72+ COLLINS CONDOMINIUM

7134 Collins Avenue
Miami Beach, Florida 33141

DESIGN REVIEW BOARD PRESENTATION

LEVEL 9 - BUILDING PLAN | 1

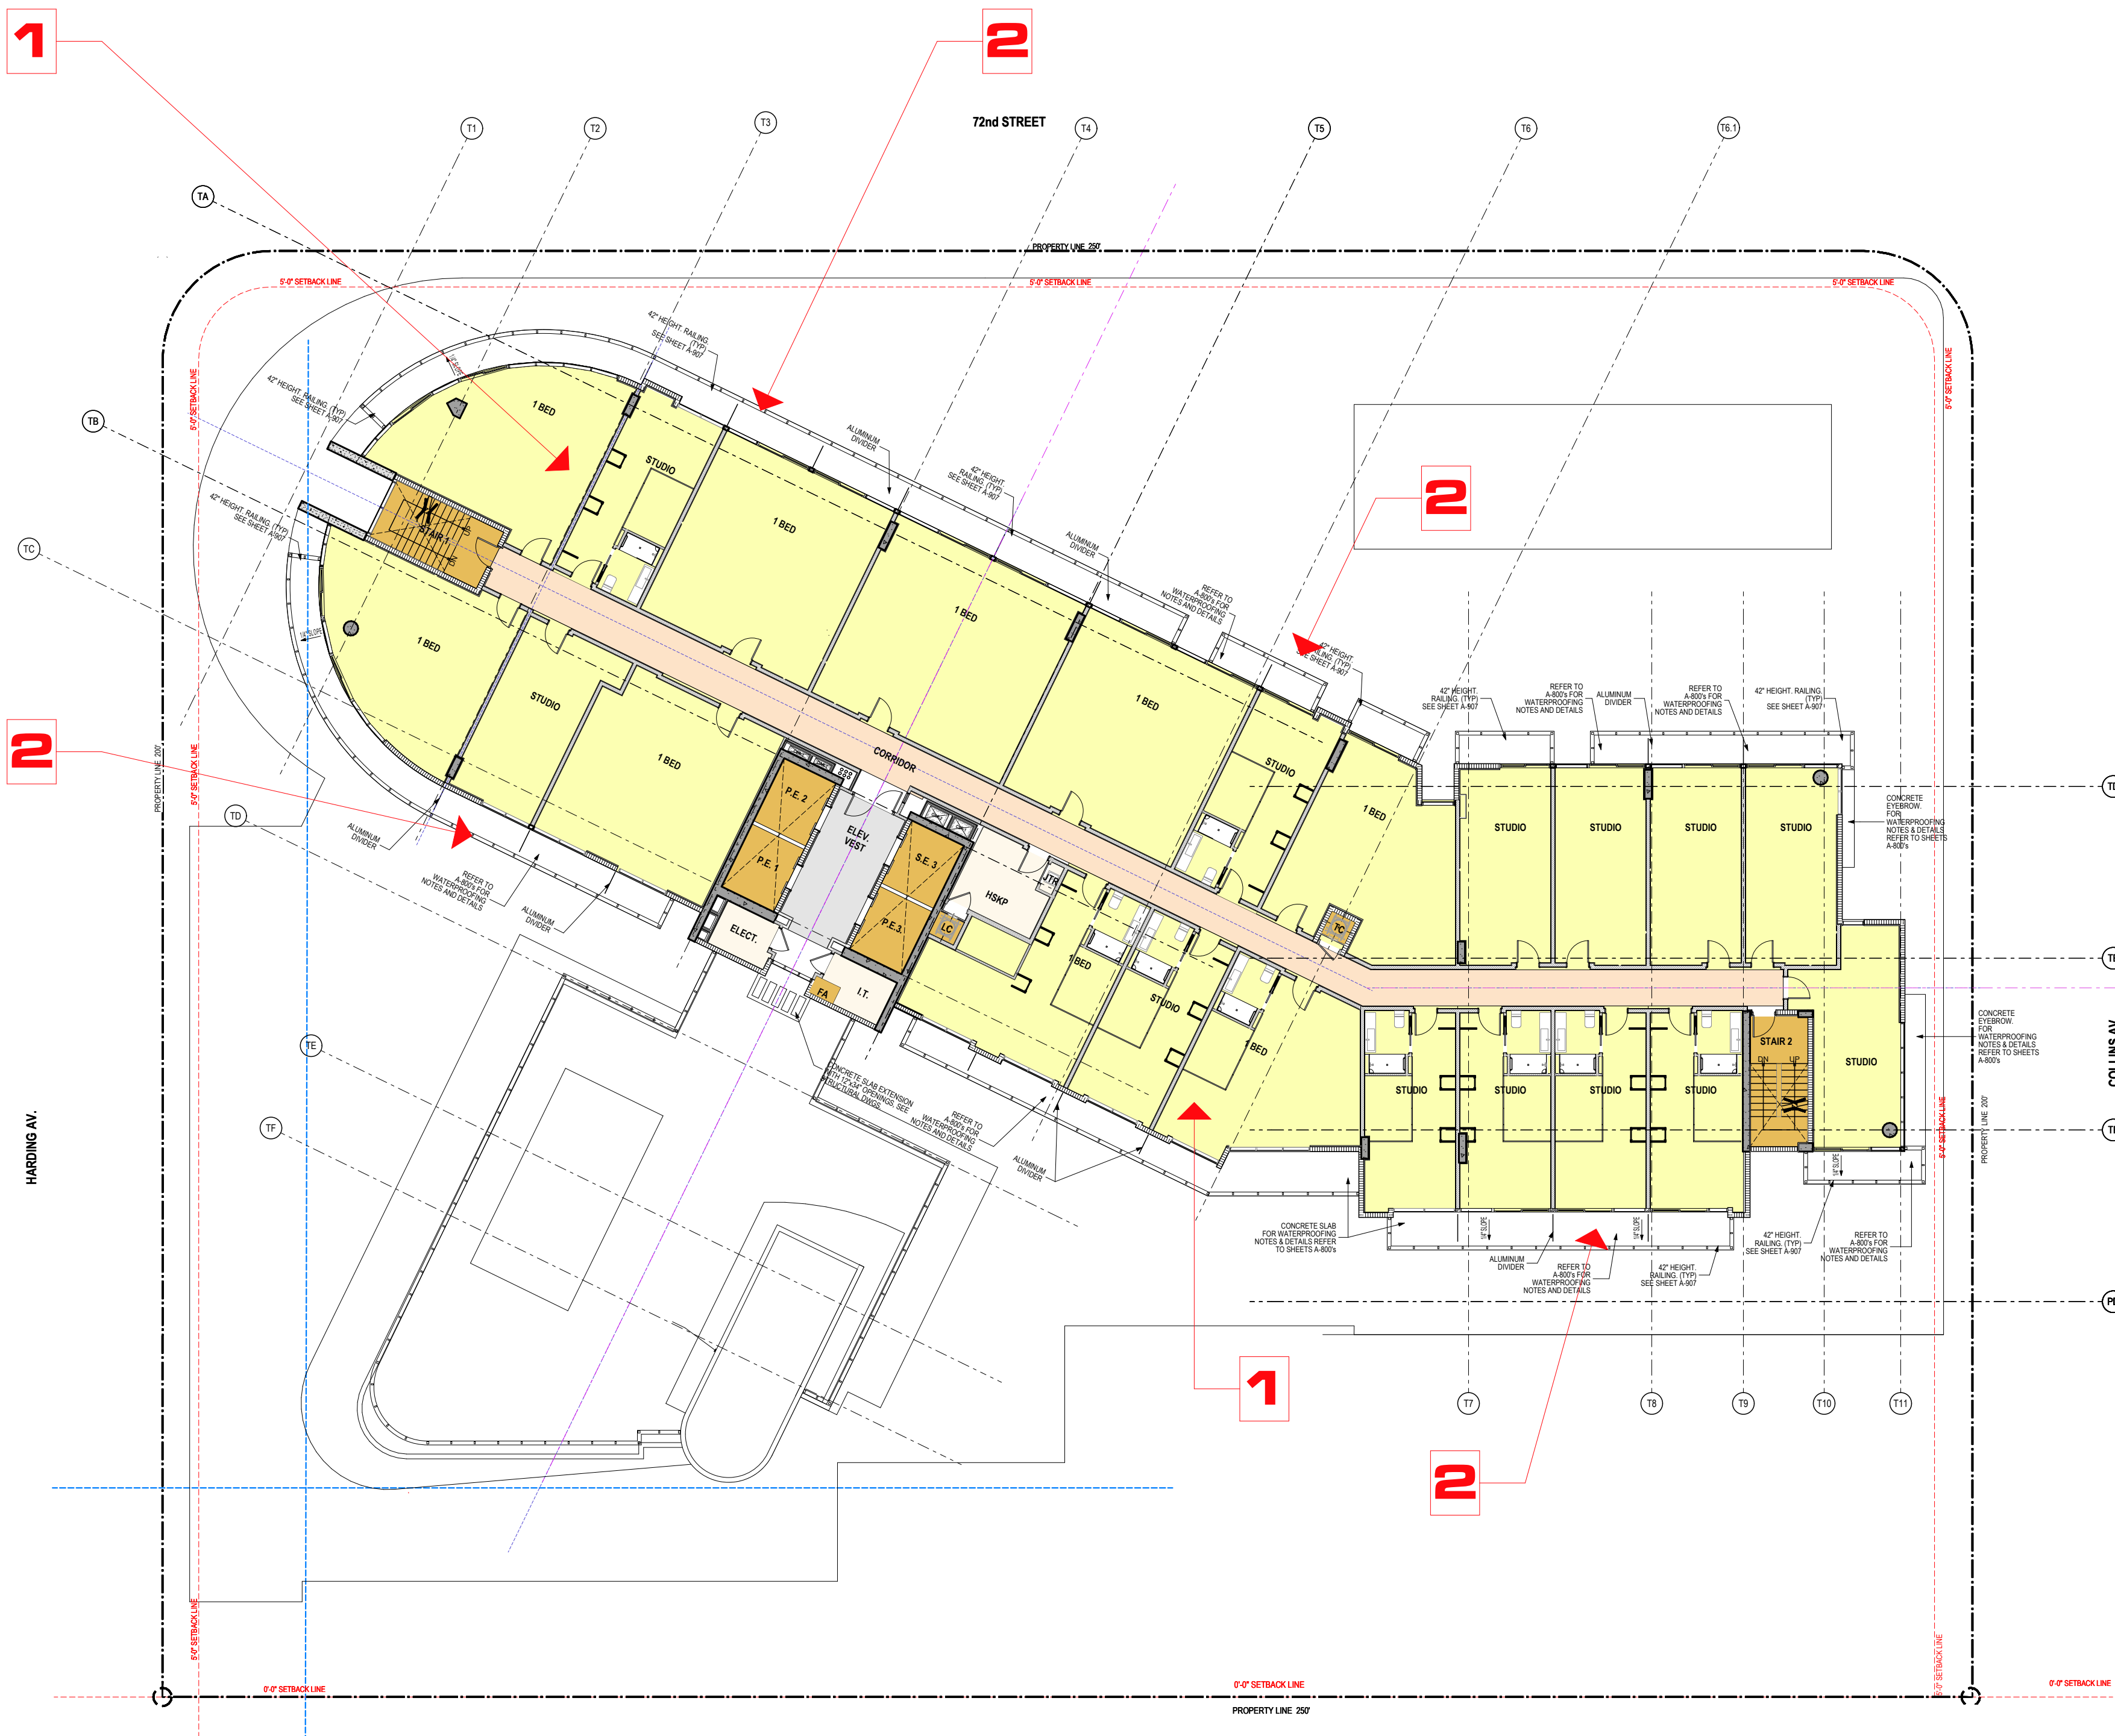
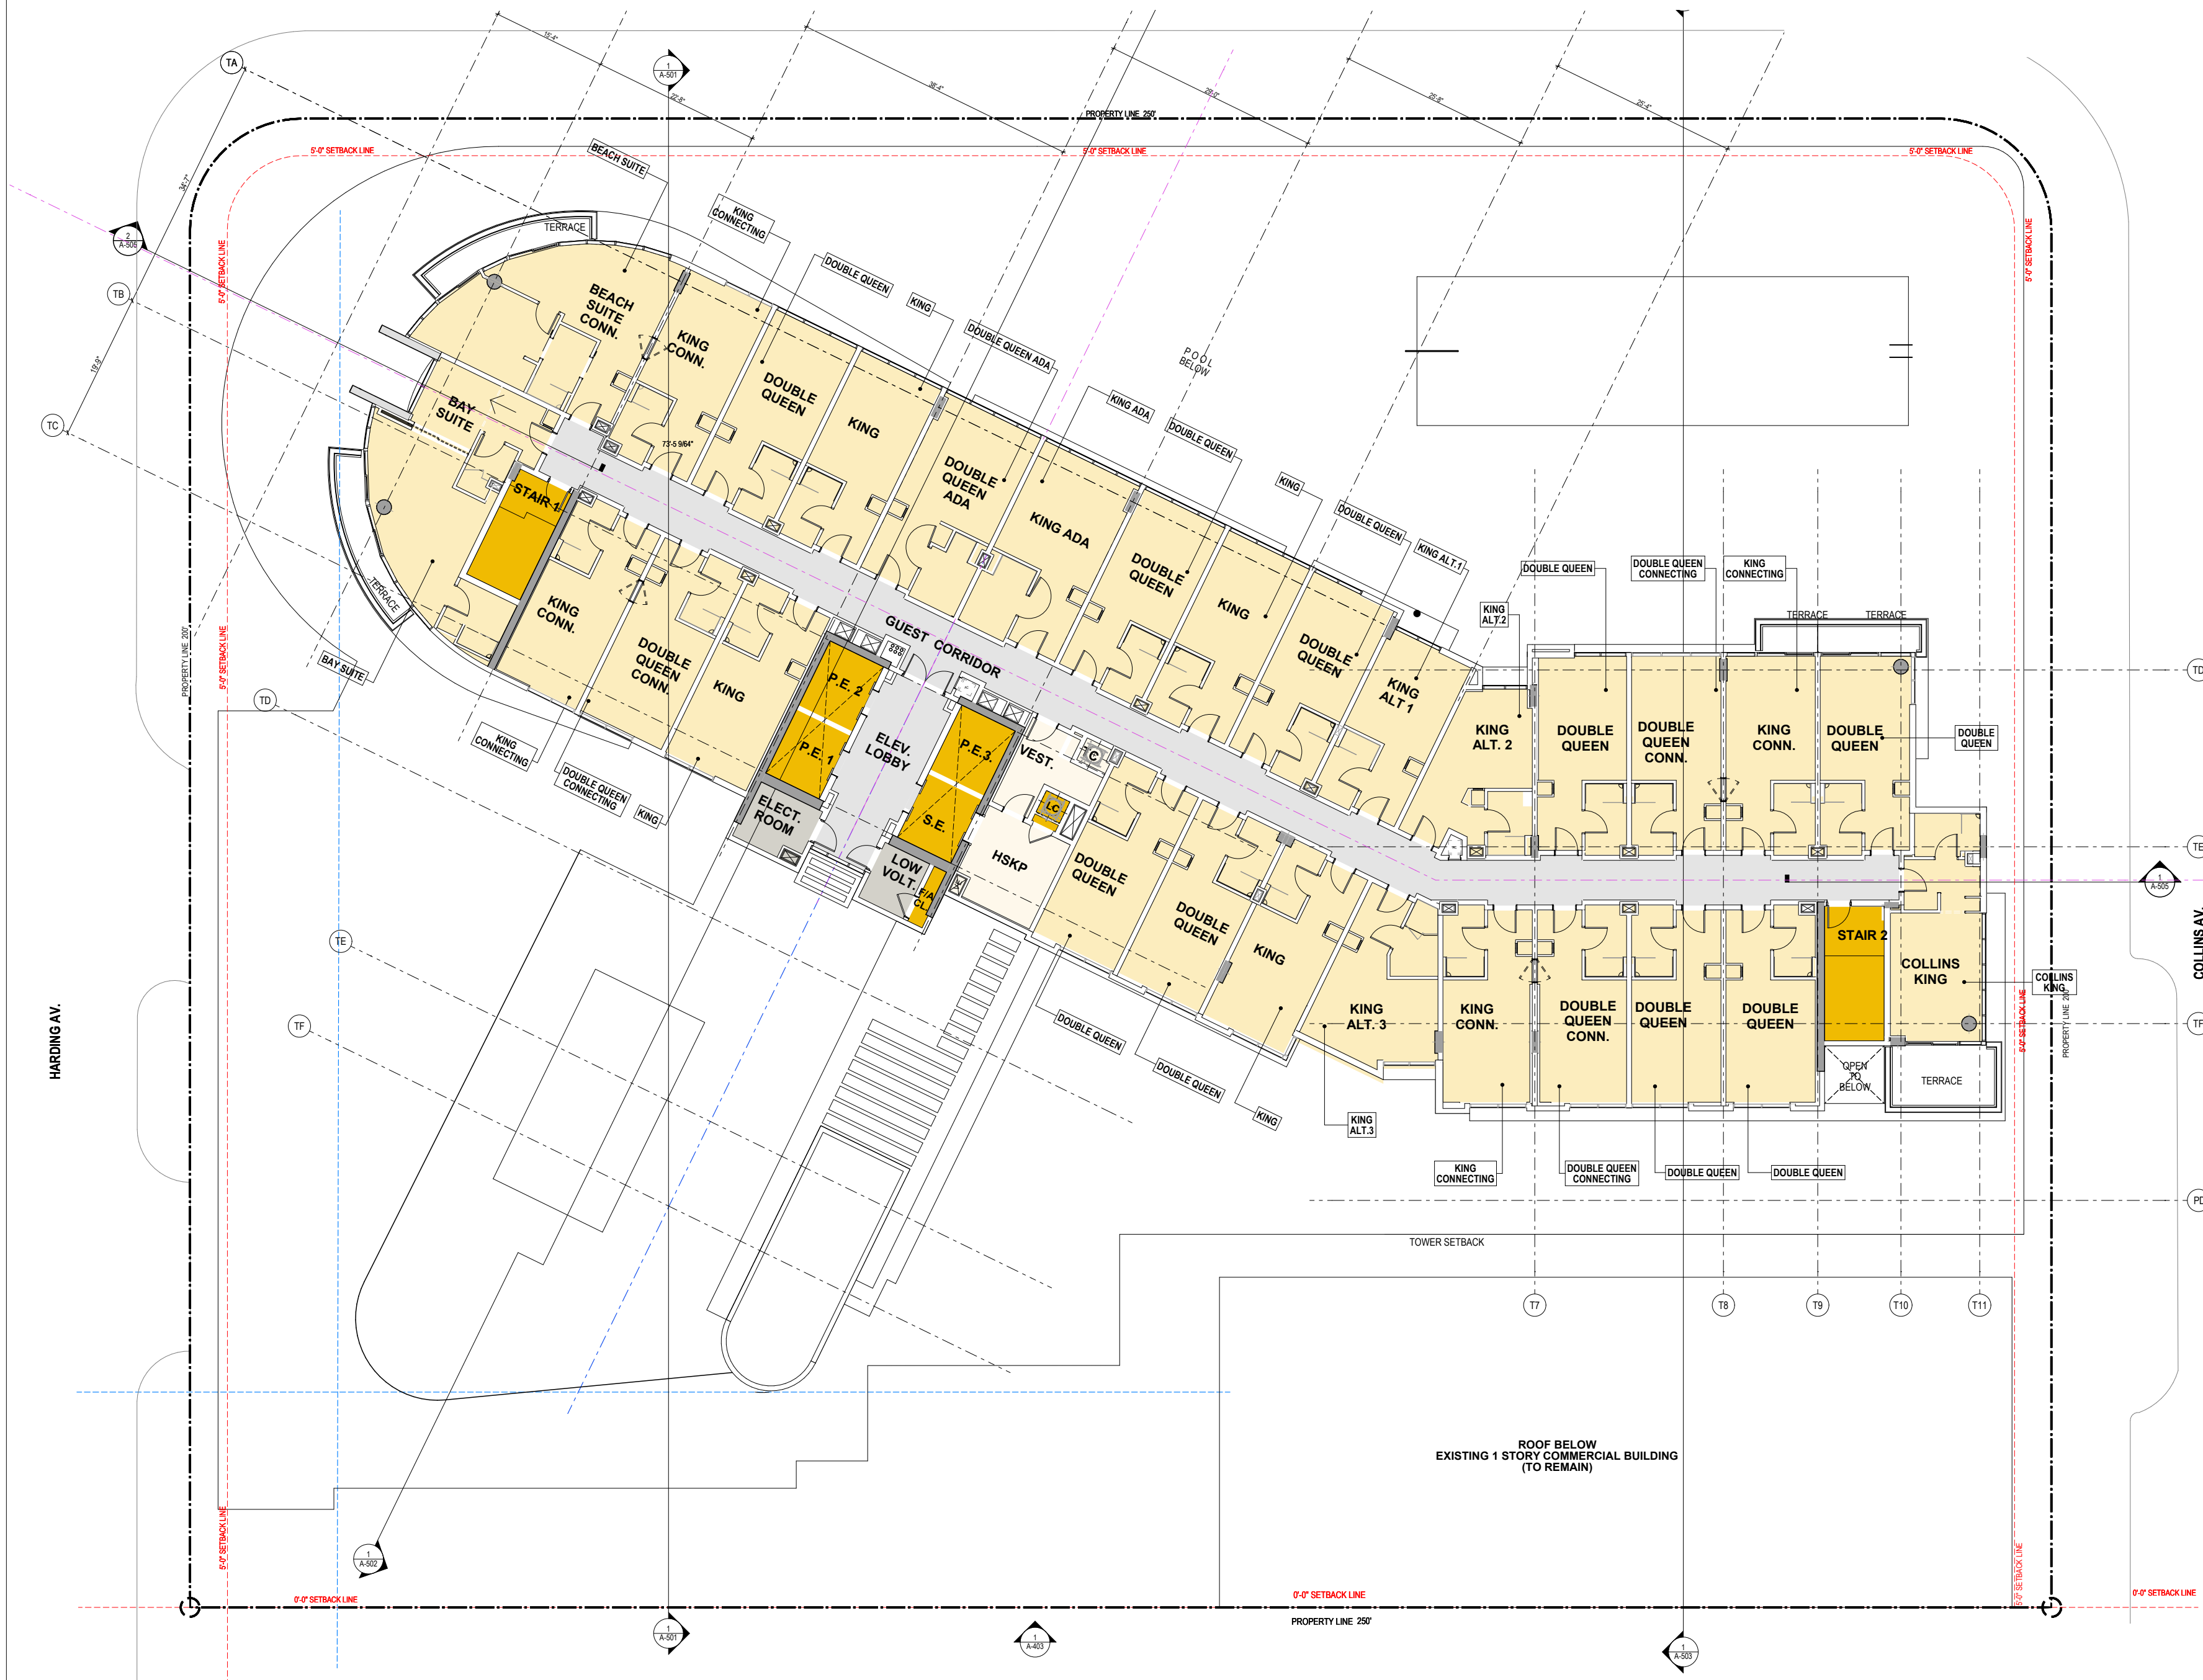
- INTERIOR ORGANIZATION TO ACCOMMODATE CO-LIVING UNITS AND NEW REGULAR UNITS
- REPLACING OF PREVIOUSLY APPROVED EYEBROWS BY BALCONIES AT NEW CO-LIVING AND REGULAR UNITS

LEVEL 10 - BUILDING PLAN | 1

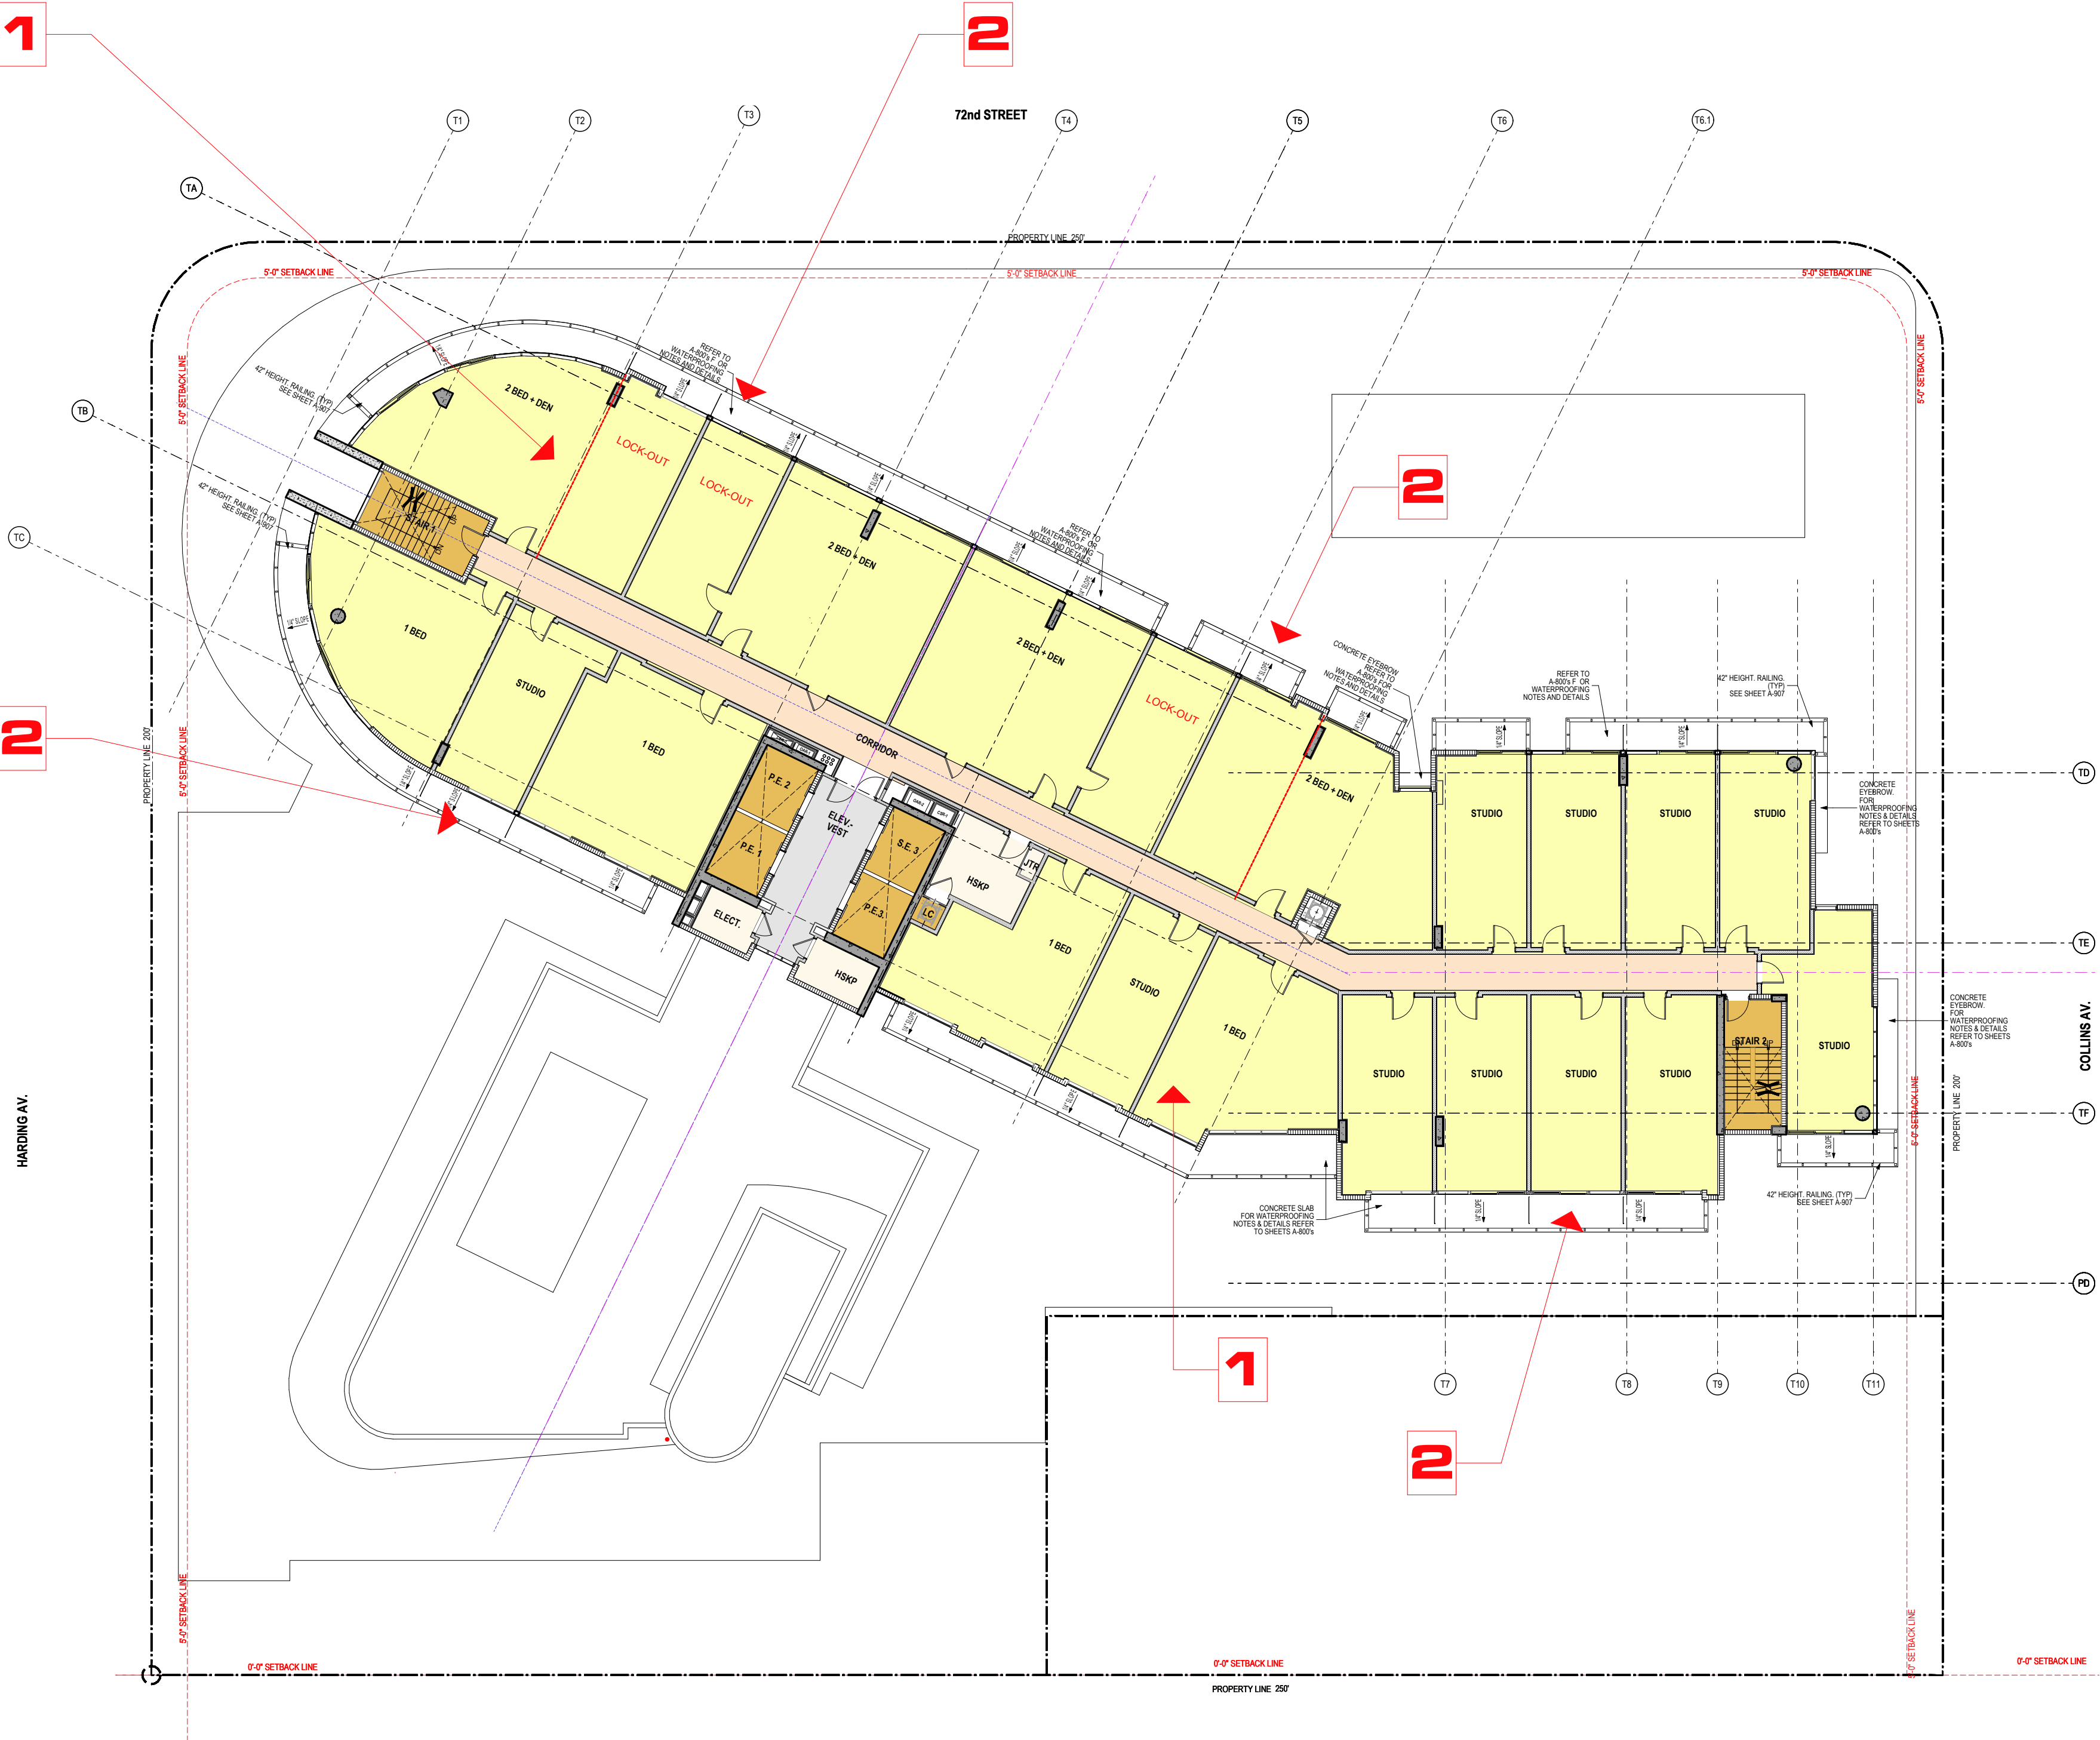
- INTERIOR ORGANIZATION TO ACCOMMODATE CO-LIVING UNITS AND NEW REGULAR UNITS
- REPLACING OF PREVIOUSLY APPROVED EYEBROWS BY BALCONIES AT NEW CO-LIVING AND REGULAR UNITS
